March 7, 2024

Planning Commission

Information Packet

The Estates at Twenty Wells PUD Summary and Recommendation

Figure 4-1. Existing Flood Protection Infrastructure

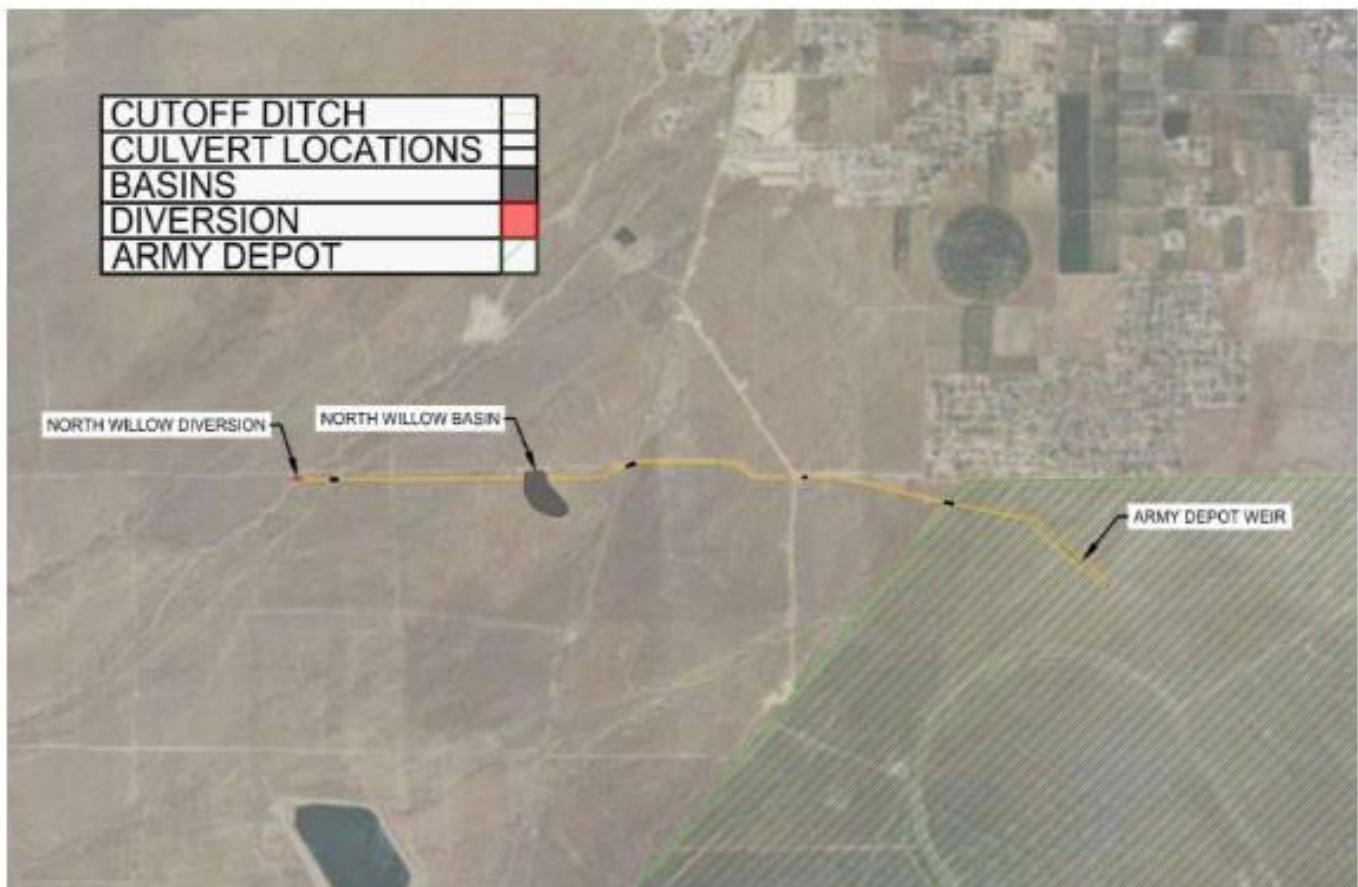
- The drainage study for offsite and onsite storm water will be crucial.
- Soils are noted as silty loam and silty clay loam. Infiltration will need to be confirmed with a geotechnical report and percolation tests.
- Main offsite drainage through the project will be conveyed along Mallory Way via roadside swales. These drainage channels have stormwater runoff through the Tooele County and Army Corps flood protection facilities from South Willow, Coal Pit, and North Willow Canyon along with West Army Creek and East Army Creek drainage areas, see images below.

Source: *Watershed Map from Grantsville City FEMA BRIC Flood Protection Scoping Study by Jones and DeMille Engineering dated February 6, 2024*

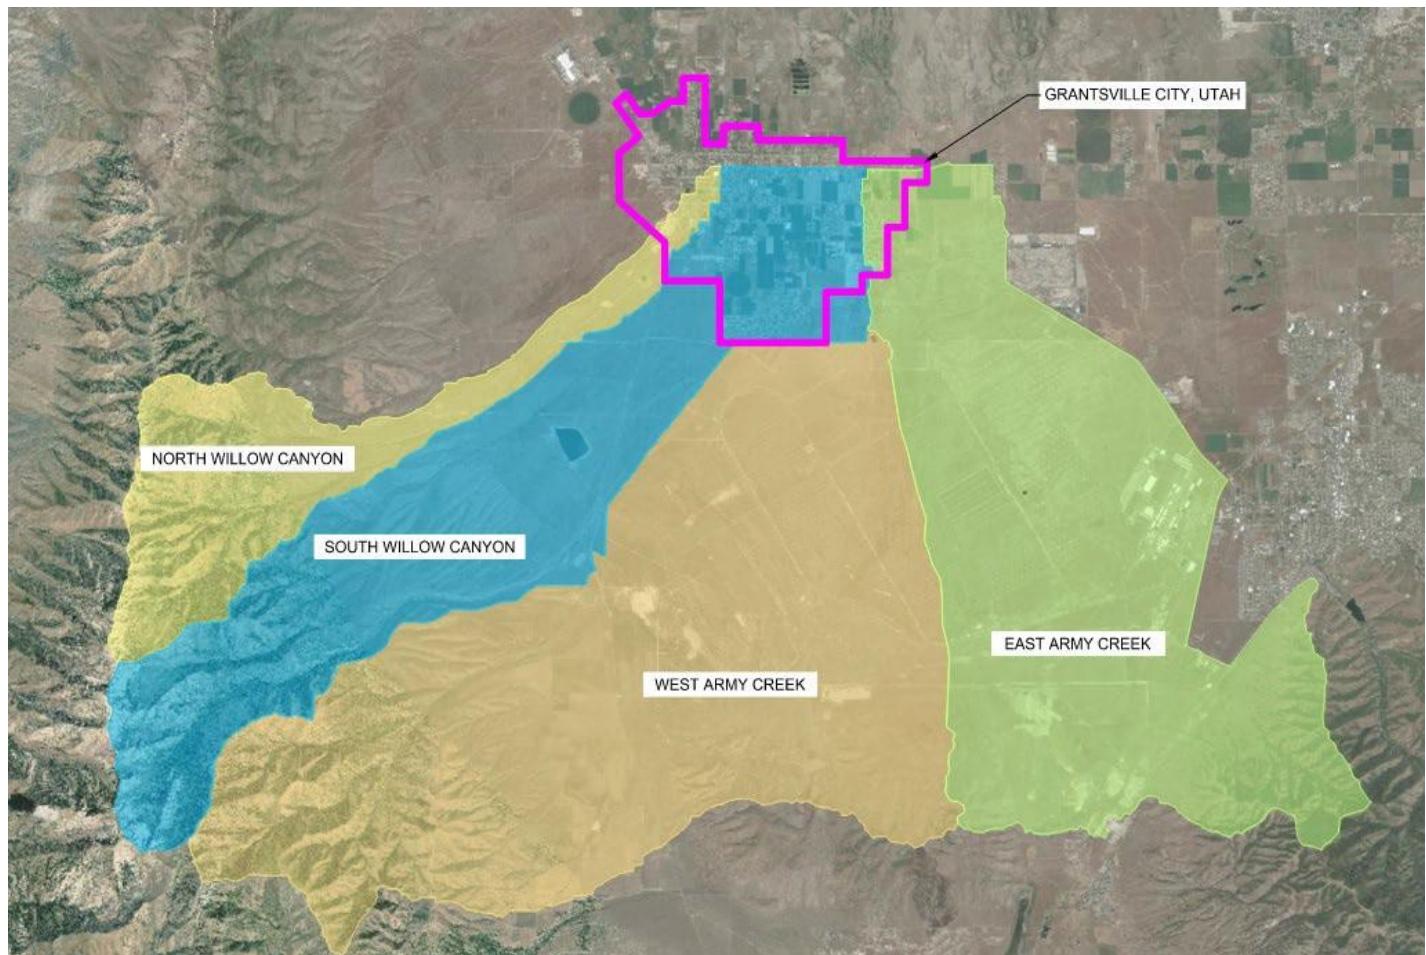
- The roadside swales in Mallory Way should have check dams or swales, if feasible, to slow down flow allowing a portion to infiltration incorporating low impact development features.
- Strom drainage for the site will be routed through an existing culvert under State Route 112. Developments north of State Route 112 will need to adequately continue to convey this flow and ultimately a larger culvert may need to be installed under SR138 to not affect downstream properties. This will need to be coordinated with Development, City, and UDOT.

- **Offsite Water Line**

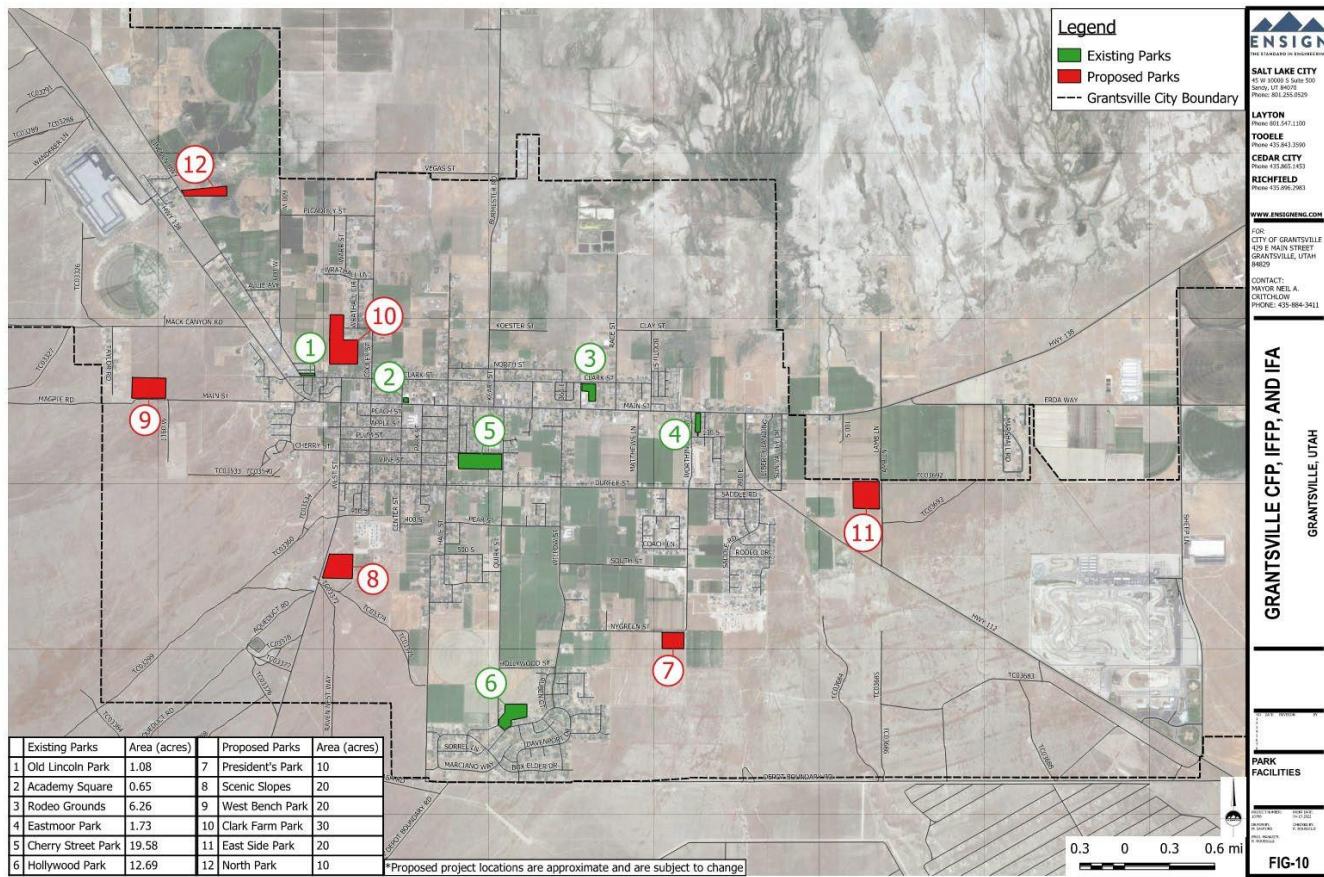
- When taking in consideration the water line connections of Nygreen Street and Durfee Street, the 12-inch water line through the development connecting to the 16-inch transmission line along the north Depot property could have been an 8-inch to address fire flow. However, the developer is proposing the 12-inch upsize to benefit other future developments. Installation of an additional connection off the 16-inch transmission line provides opportunities for additional development along SR-112 while allowing future benefits of looping with future water lines through Lakeview Business Park and along SR-112.

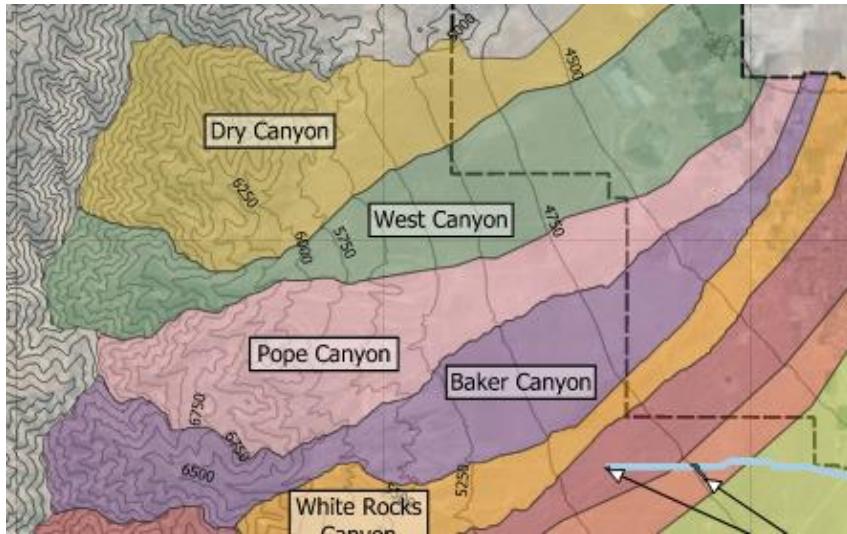
- The drainage study for offsite and onsite storm water will be crucial. This project conveys stormwater from the Baker Canyon Watershed, see figure below.

development is preserving the major drainage corridor through the development as open space. It is recommended to incorporate channel infiltration basins at road crossings to infiltrate this storm water. Once the drainage passes under an existing culvert under SR-138 it flows into industrial property. This is an existing condition.
